Raspberry Pi Zero Camera Cable

PCN 48 – Zero Camera Cable form factor and manufacturing change

Change of form factor and manufacturer of the Raspberry Pi Zero camera cable.

Comparison Images (150mm variant, Front)

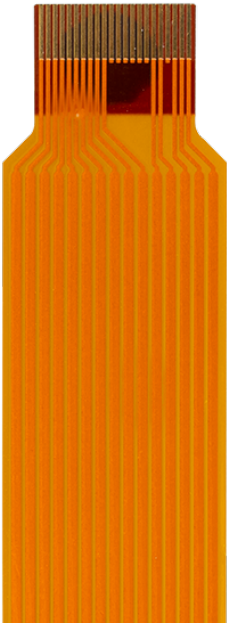
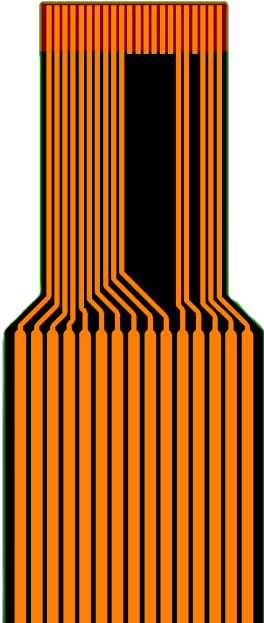
The narrow section on the 150mm cable has been increased in length to prevent mechanical interference with HATs when used on the Raspberry Pi 5.
